DDS- Planning & Zoning: Plan Review Application

Please describe your application action(s) and provide as much detail as possible. Attach additional pages if necessary: **special permit for outdoor drinking patio**

HOG RIVER BREWERY RELOCATION
 1420 Park St.
 Hartford, CT 06106

From: Paul Ashworth
Sent: Wednesday, July 13, 2022 3:34 PM
To: Berschet, Paige; Natalie Sweeney
Cc: Hartford Planning Division
Subject: RE: 1420 Park St - Special Permit Application - P&Z-COMM-2022-0264

1 PROPOSED SITE PLAN & ZONING INFORMATION

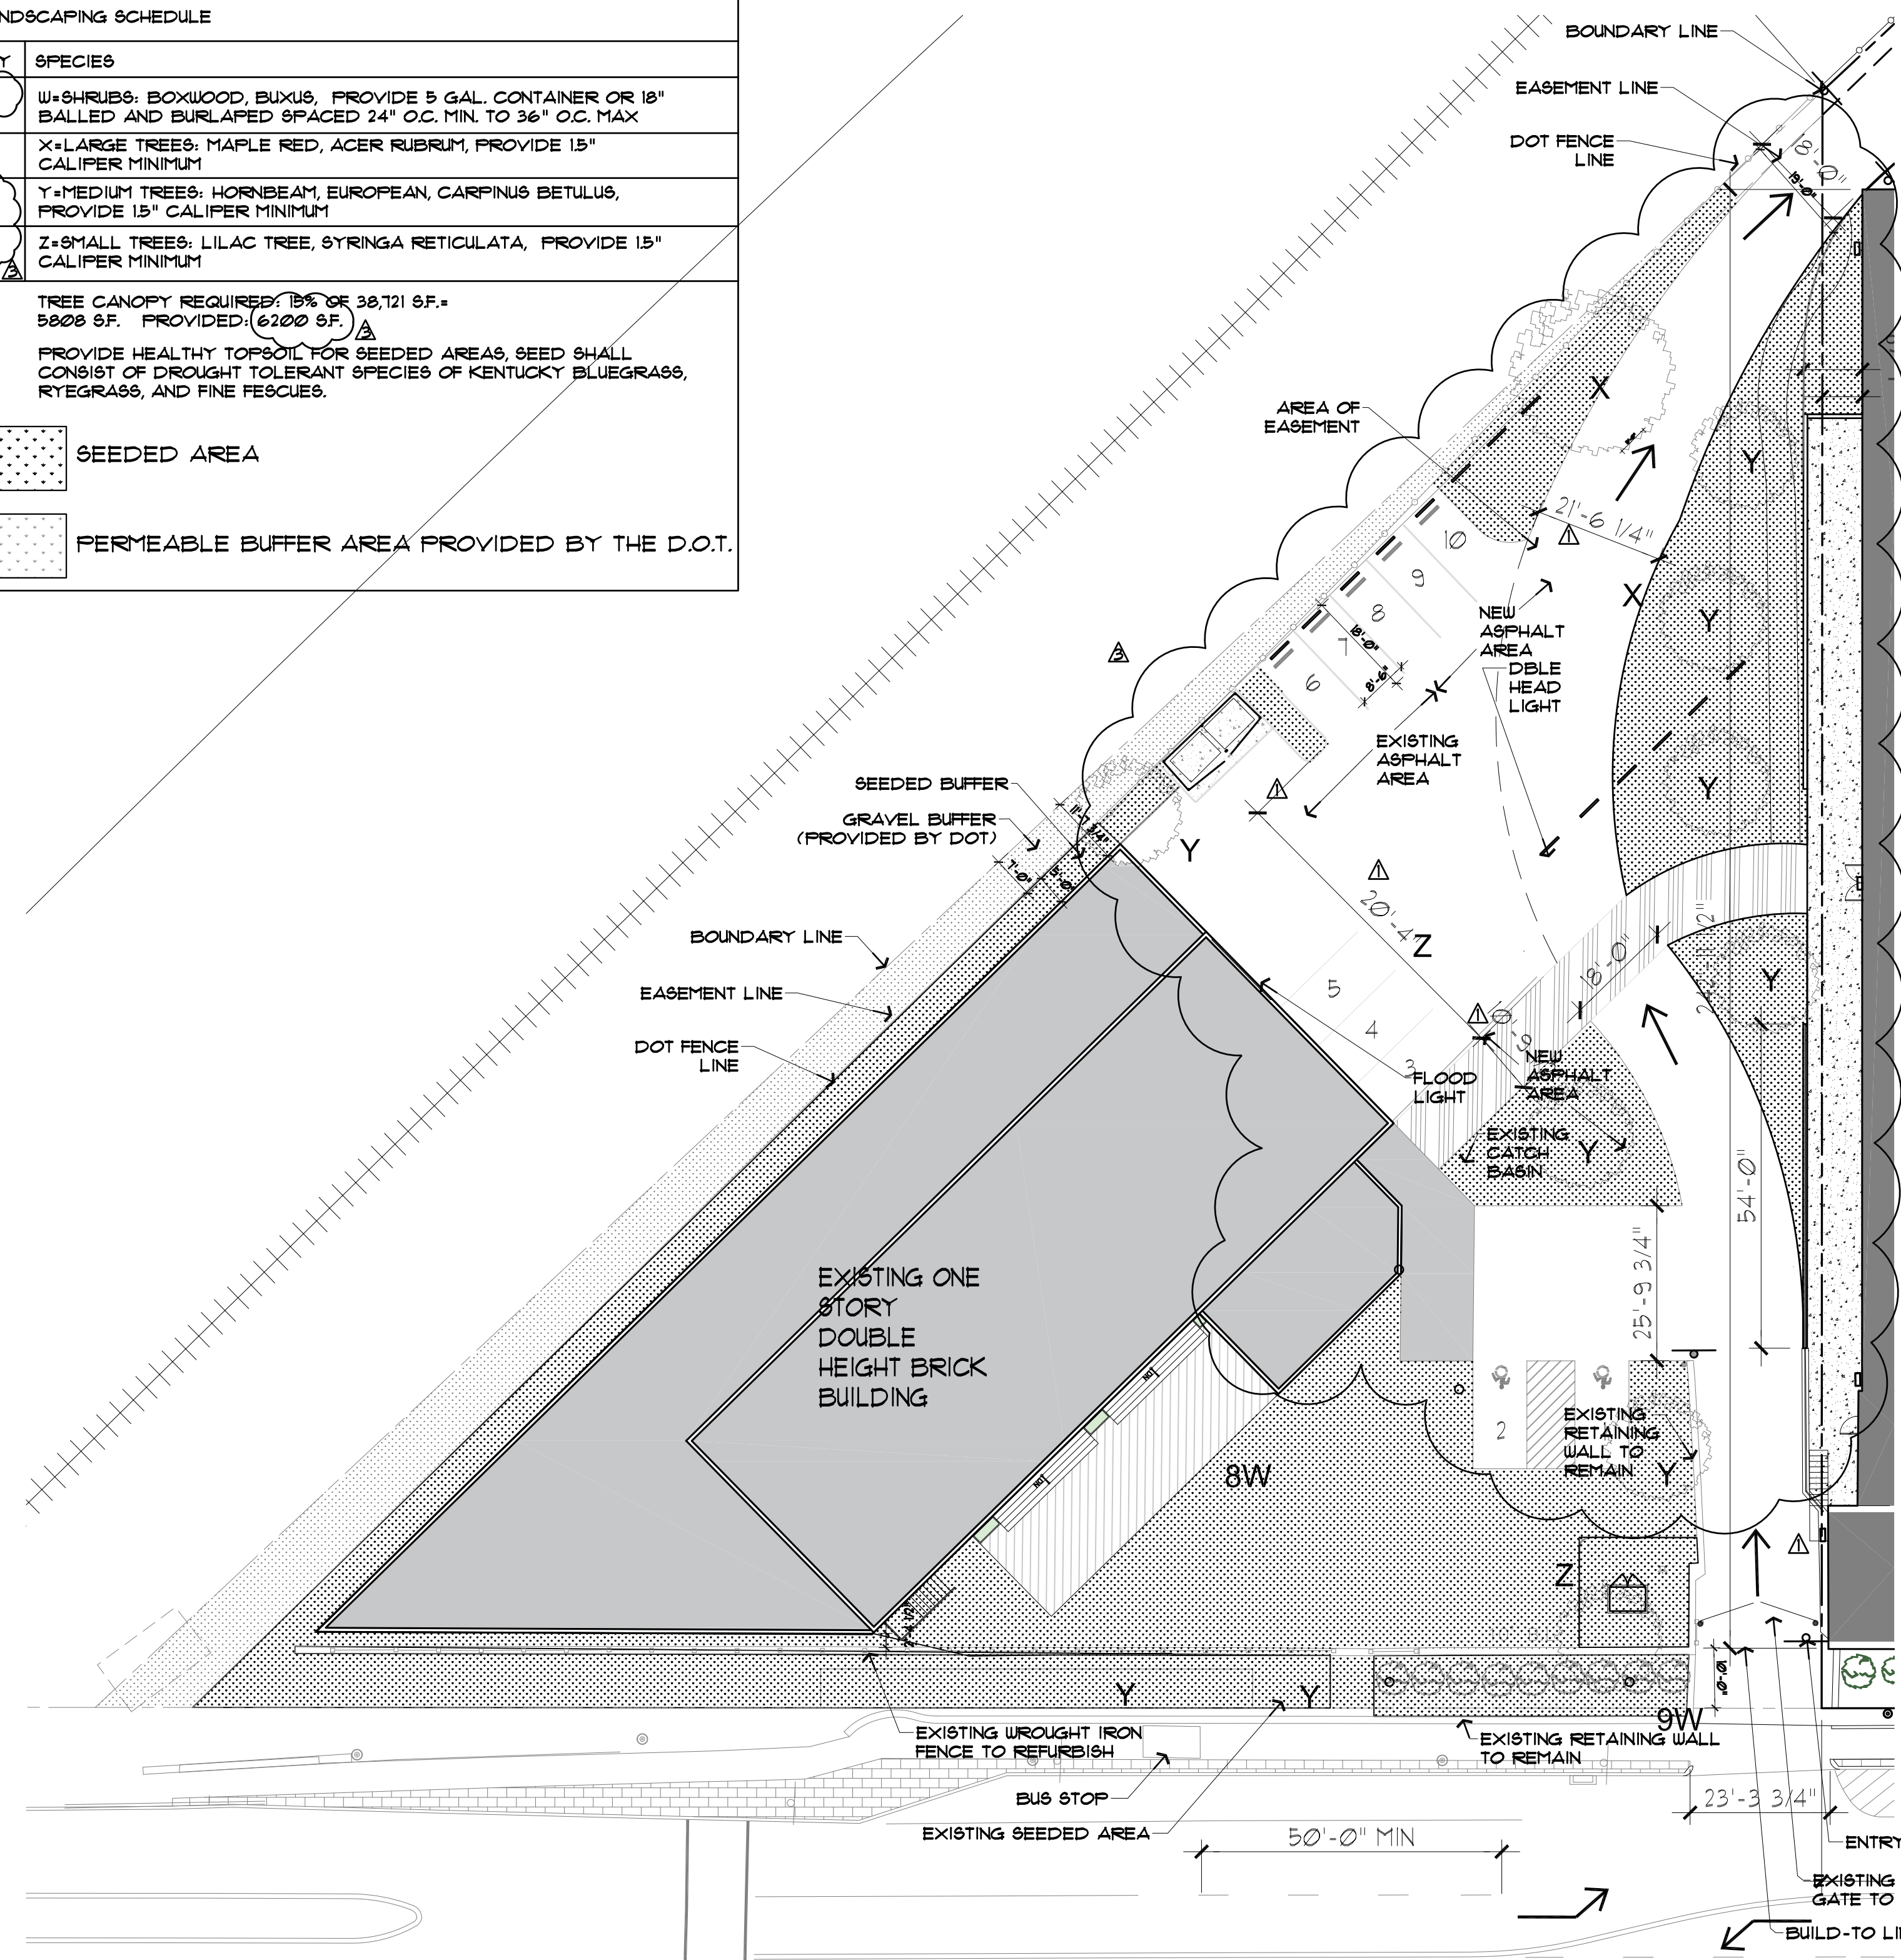
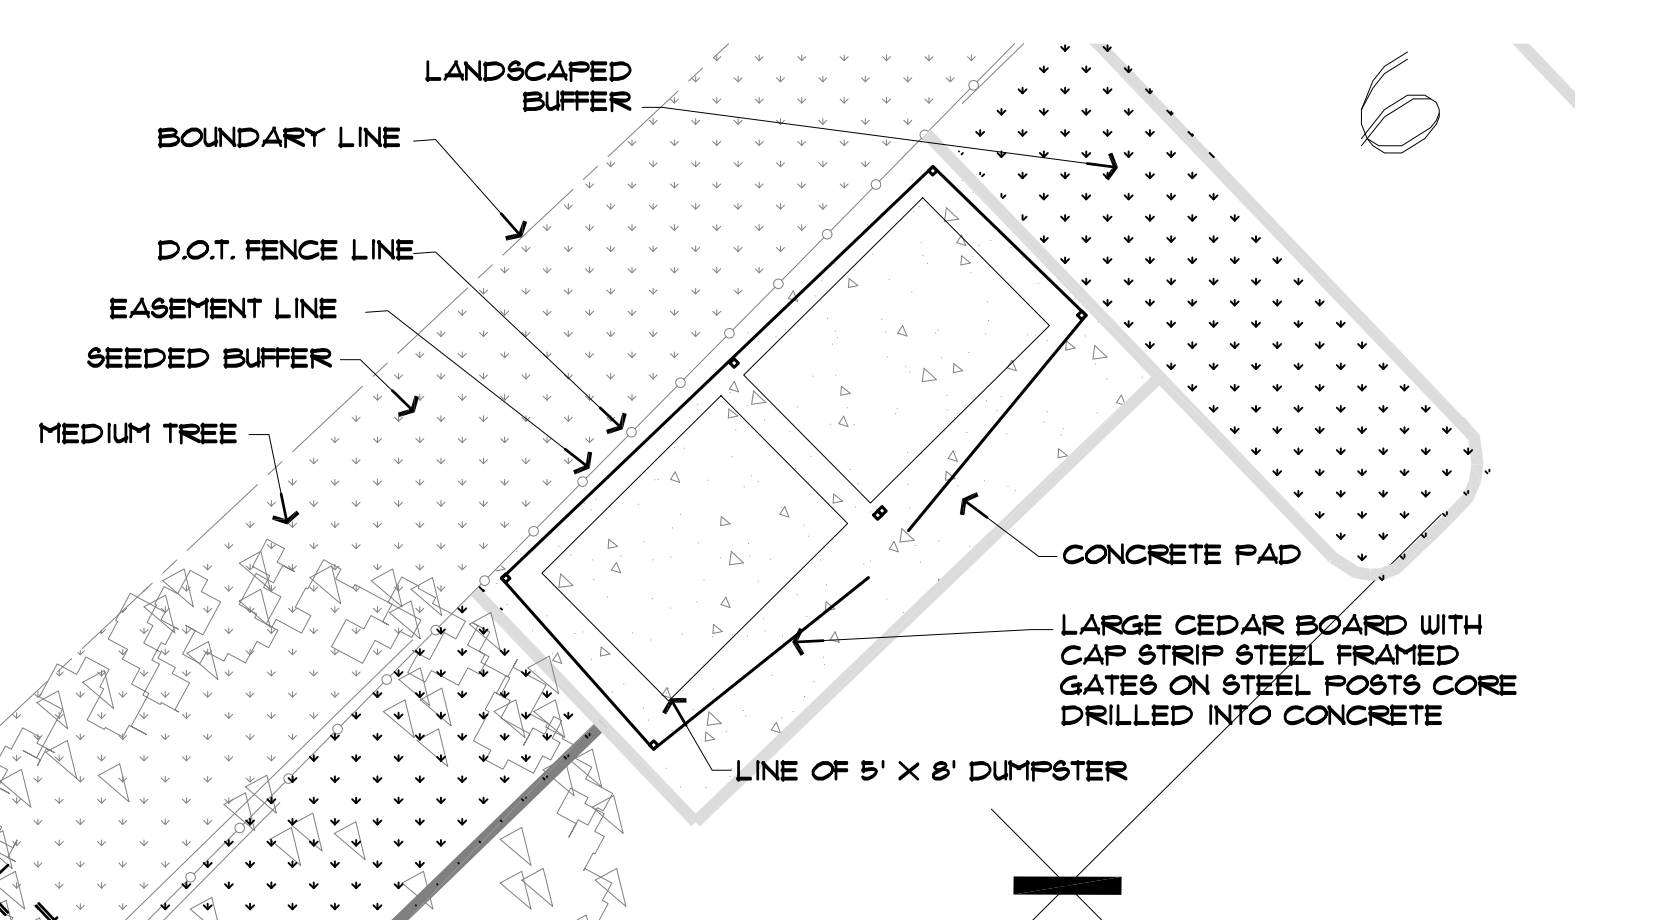
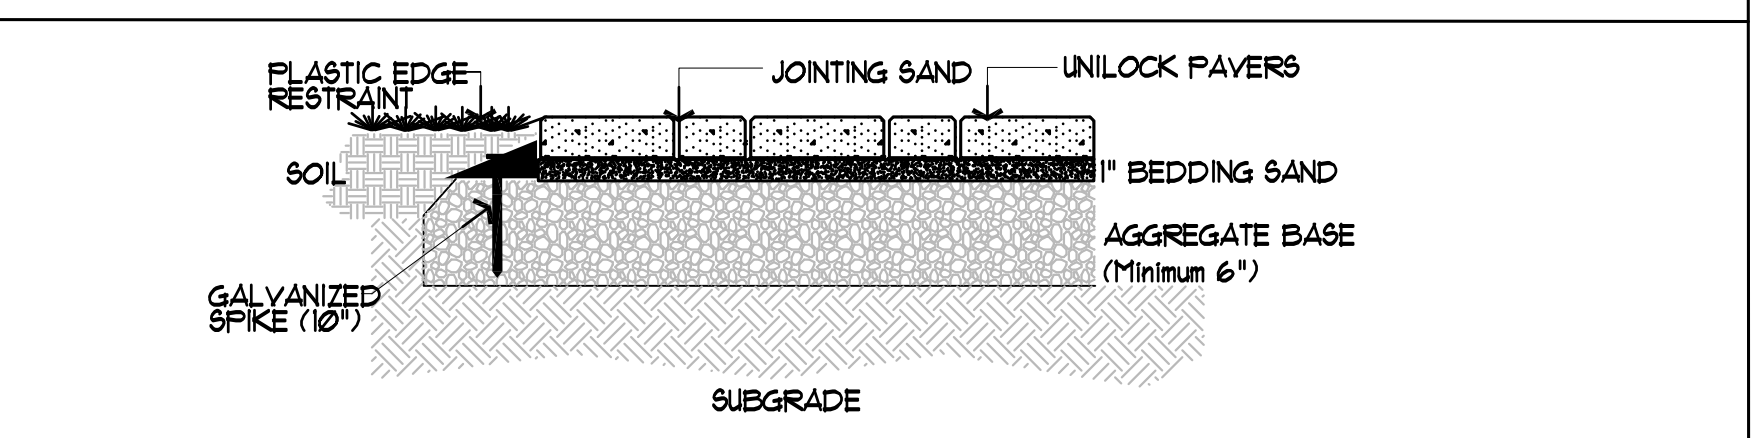
1. Please include a survey in the plan set.
2. Landscape plan was delivered to the City Forester's representative for review.
3. In zoning table on sheet SP-1. Multiple items are marked "Variance Accorded". I don't see a variance(s) on file. Please provide verification of a variance issued by the Zoning Board of Appeals for these items. Please note items #2 and #16 do not require variances. Item number 24 and 25 should be met.
4. Front entrance should be accessible from the street and not required to cross a separate parcel for entrance. Please show a pedestrian accessway from the bus stop directly to the front entrance of the building.

5. Section 4 on sheet SP-1 implies there is a minimum number of parking spaces and does not reflect City of Hartford parking requirements. Maximum parking for this use is 4 spaces per 1000 sf (see employment uses [i.e.craftsman industrial] in Fig.7.2-A). Revise table to show adherence with Hartford regulations.
6. Bicycle parking cannot be more than 50' from the entrance to a building and located on the same lot per Sec.7.3.3. Please show bicycle parking on site.
7. The ADA parking is currently shown in what could be the side or front yard. Parking is not permitted in this location. Please remove from the plan.
Staff found no record of parking being approved in this location in the past.

8. Please confirm parking lot lighting and site lighting is compliant w/ section 7.3.1.J and section 6.15.2 respectively. Please confirm fixture types and provide a photometric plan showing illuminance of the parking and pedestrian areas.
9. Please provide a demolition plan identifying paving to be removed or replaced. Please note new pavement must meet the requirements of section 7.3.1.H.
10. Please provide an erosion control plan or confirm the scope will not trigger section 6.16.3.
11. It appears the total impervious area will be increased. Please provide a stormwater management plan consistent with Section 6.14.2.C unless you can demonstrate how the scope is exempt per section 6.14.2.C(4). If exempt please confirm how the basic requirements of section A are met (6.14.2.A).
12. Please confirm how the tree requirement is met. 15% tree canopy coverage is required in the CX districts.

1. Please include a survey in the plan set. **Survey is included.**
2. Landscape plan was delivered to the City Forester’s representative for review. **Lansdaping Distribution has been revised.**
3. In zoning table on sheet SP-1. Multiple items are marked “Variance Accorded”. I don’t see a variance(s) on file. Please provide verification of a variance issued by the Zoning Board of Appeals for these items. Please note items #2 and #16 do not require variances. Item number 24 and 25 should be met. **Variances attached**

4. Section 4 on sheet SP-1 implies there is a minimum number of parking spaces and does not reflect City of Hartford parking requirements. Maximum parking for this use is 4 spaces per 1000 sf (see employment uses [i.e.craftsman industrial] in Fig.7.2-A). Revise table to show adherence with Hartford regulations. **Table revised on SP-1.**
5. Bicycle parking cannot be more than 50’ from the entrance to a building and located on the same lot per Sec.7.3.3. Please show bicycle parking on site. **Shown on Sp-1.**
6. The ADA parking is currently shown in what could be the side or front yard. Parking is not permitted in this location. Please remove from the plan. **Parking was removed.** Staff found no record of parking being approved in this location in the past.

12. Please confirm how the tree requirement is met. 15% tree canopy coverage is required in the CX districts. **See plant legend on SP-1**
